2023/5086/P - 11 Perrin's Lane, NW3 1QY

Delegated Report (Members Briefing)		Analysis sheet		Expiry Date:	19/01/2024
		N/A / attached		Consultation Expiry Date:	04/02/2024
Officer				Application Number(s)	
Christopher Smith				2023/5086/P	
Application Address				Drawing Numbers	
11 Perrin's Lane London NW3 1QY				See draft decision notice	
PO 3/4	Area Team Signature	C&UD	Authorised Officer Signature		
Proposal(s)					
Erection of first floor rear extension and pitched roof extension incorporating front dormer, and other minor alterations.					
Recommendation(s):		Grant Conditional Planning Permission			
Application Type:		Householder Application

Proposal: Erection of first floor rear extension and pitched roof extension incorporating front dormer, and other minor alterations.

Fig. 1: Proposed Elevation of Terrace Properties Nos. 5-11 Perrin's Lane

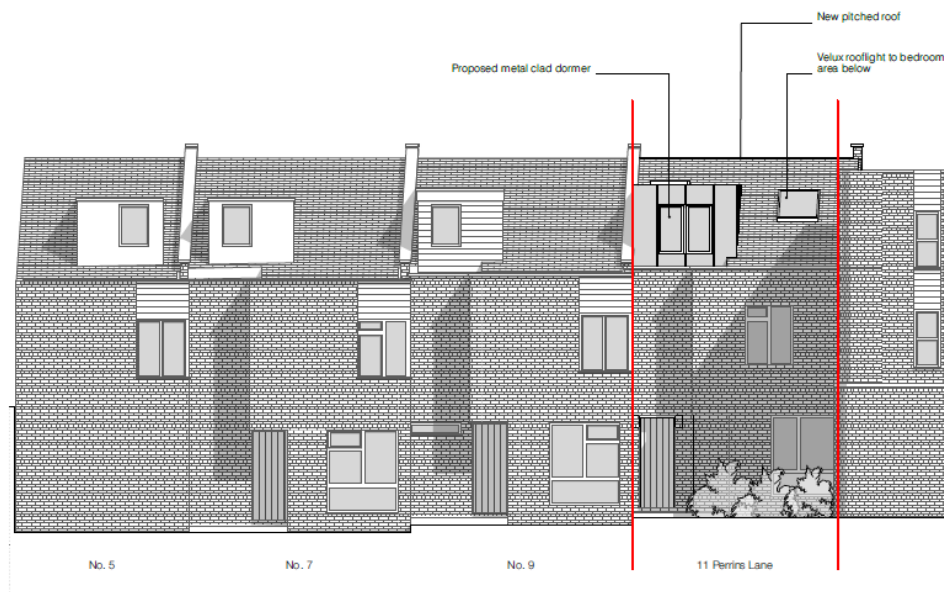
- 3.6. The proposed front dormer would be slightly larger than the existing dormers on this part of Perrin's Lane. However, its size is reflective of current insulation standards which necessitates the additional height and width compared to those historic neighbouring dormers, whilst the material finish would have an attractive and robust metal finish.

- 3.9. The position of the front door would change and a clerestory window on the front elevation would be removed (the front elevation of the host property is currently laid out similarly to no. 9 – see Fig.1 above) as part of this proposal. These works would change the pattern of fenestration on the front of the property so it would contrast further with the other properties in this terrace at ground floor level. However, there is already limited consistency between the front elevation of the host property and other properties in this relatively small terrace due to its lack of roof and front dormer, which this application would partially rectify. No.5 does not have

Fig. 3: Proposed First Floor (left) and Proposed (right) Roof Plans

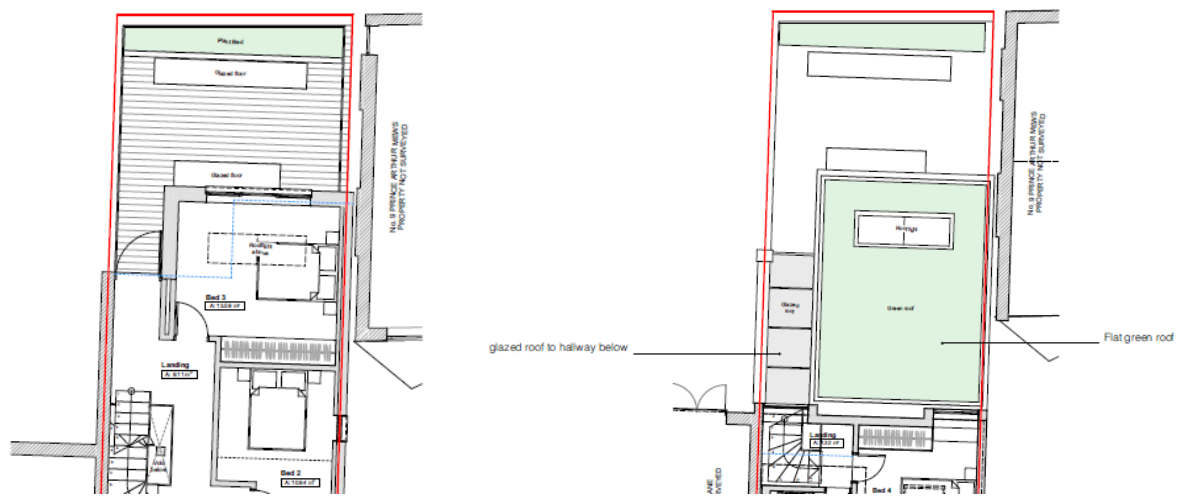
- 3.12. At first floor level the development would extend slightly deeper to the rear than the existing first floor rear projection (see left image in Fig.3 below). This would add little additional bulk and massing to the existing building at first floor level, and in any case this additional first floor element would not be visible from surrounding streets. The existing rear lightwell would be replaced entirely, with the side wall of the property proposed to be entirely clad in shiplap timber cladding above ground floor level on its south-western side, and the roof of the first floor projection proposed to be finished mainly with a flat green 'sedum' roof and also partially, on the northern side of the first floor, with a new glazed roof, which would provide increased light to the hallway below (see right image in Fig. 3 below).

- 8 Prior to commencement of development, full details in respect of the living roof to the rear of the proposed extension at first floor level shall be submitted to and approved by the local planning authority. The details shall include:
- i. a detailed scheme of maintenance,
 - ii. sections at a scale of 1:20 with manufacturer's details demonstrating the construction and materials used,
 - iii. full details of planting species and density.

Fig. 4: Existing (left) and Proposed (right) South-Western Elevation

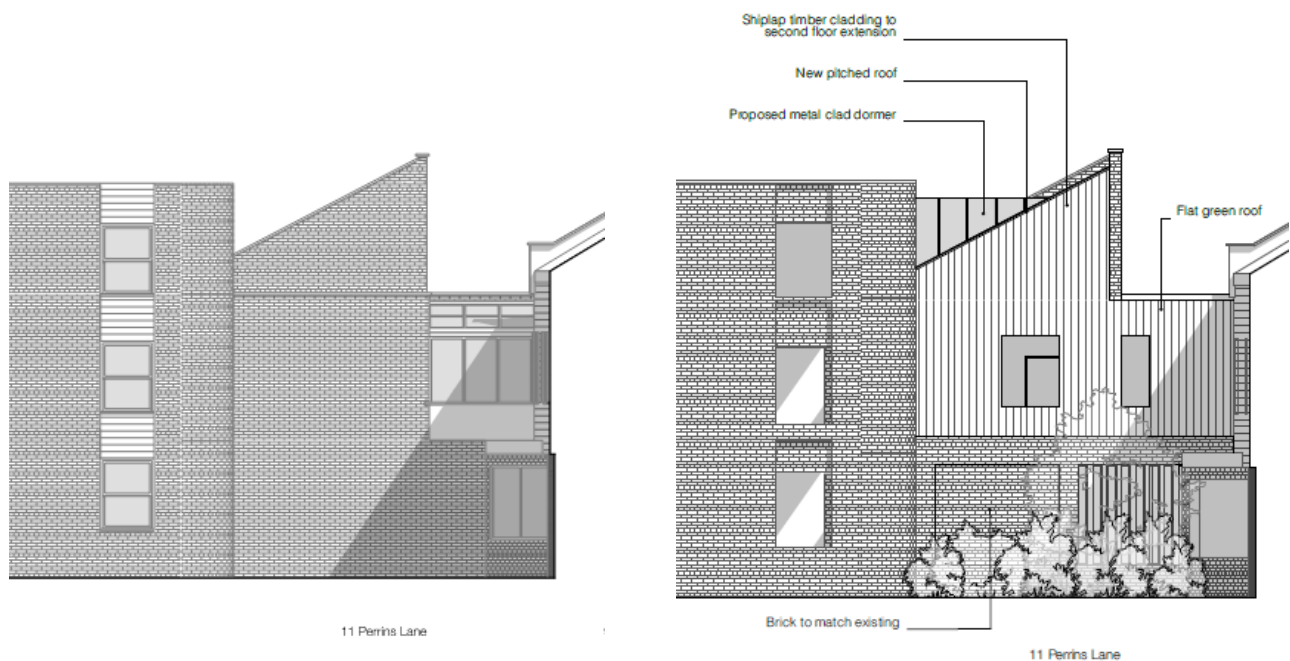
3.13. The appearance of the south-western side elevation of the property would also change at ground floor level through the installation of a decorative recessed brick feature and slatted brick opening which would enable light and air to flow into the proposed ground floor internal courtyard. These features would add visual interest to the existing blank side elevation and would only be visible from the private gated courtyard at the far rear of Prince Arthur Mews (see south-western elevation below in Fig.4 – the host property is sited between a three-storey brick-finished building at 13 Perrin's Lane to the left of the image and a two-storey house no. 9 Prince Arthur Mews to the right of it). As such, they are considered acceptable from a design and heritage perspective.

- 10 Full details (including drawings at 1:20 scale) of the proposed material treatment on the ground floor of the south-western elevation fronting onto Prince Arthur Mews shall be submitted to the local planning authority for its written approval prior to the commencement of the development.
